**To:** Summey Engineering Associates  
**From:** Jeff Walton, Associate Planner; 910-341-3260  
**CC:** File;  
**Date:** 5/11/2023  
**Re:** Cookout – Market Street

The following is a list of comments for review from planning regarding the project. Please provide your corrections as listed below. A staff summary of comments:

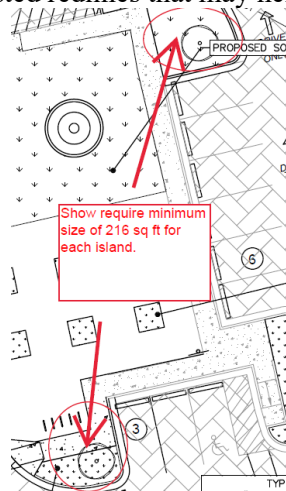
**Site Plan Comments:**
